Access Compliance Report

Public Rights-of-Way

(Curb Ramps)

Intersection ID: 47697	Main Street: NIGHT_HERON_LN	Cross Street: LEES_COURT_ST	Location: S
ADA ID: 9C091AC33FAB	Ramp Type: PerpDiag	Initial Pass/Fail: Fail	Overall Compliance: No
Severity Score: 21.25			
Codes/Mitigation Info/Possible Solution		Field Measurements/Component Compliance

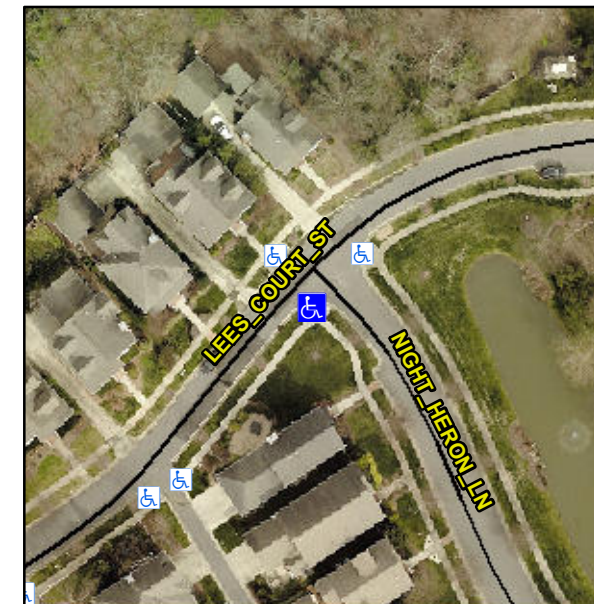
Not Found, R304.5.1, R304.2.2

Compliance	Description	Data	Compliance	Description	Data
N/A	Ramp Length (in)	70.0	No	Ramp Slope (%)	11.3
No	Ramp Width (in)	46.0	Yes	Ramp XSlope (%)	1.9
N/A	Flare Type LT	N/A	N/A	Flare Type RT	N/A
N/A	Flare Slope LT (%)	N/A	N/A	Flare Slope RT (%)	N/A
N/A	Flare Traversable LT?	N/A	N/A	Flare Traversable RT?	N/A
N/A	Landing Length (in)	N/A	N/A	DWS Provided?	N/A
N/A	Landing Width (in)	N/A	N/A	DWS Contrast?	N/A
N/A	Landing Slope (%)	N/A	N/A	DWS Length (in)	N/A
N/A	Landing X Slope (%)	N/A	N/A	DWS Full Width?	N/A
N/A	Landing Curb? (Y/N)	N/A	N/A	DWS Offset (in)	N/A
N/A	Shared Landing?	N/A			
N/A	Gutter Ponding?	N/A	N/A	Gutter Slope (%)	N/A
N/A	Gutter Lip Ht (in)	N/A	N/A	Gutter X Slope (%)	N/A
N/A	Painted X Walk1?	No	N/A	Painted X Walk2?	No
	X Walk 1 Direction	To NE		X Walk 2 Direction	To NW
N/A	X Walk 1 Width (in)	N/A	N/A	X Walk 2 Width (in)	N/A
	X Walk 1 Slope (%)	0.1		X Walk 2 Slope (%)	2.6
	X Walk 1 X Slope (%)	3.3		X Walk 2 X Slope (%)	0.8

Remove & Replace Curb Ramp With Two New Directional Ramps or Equivalent.
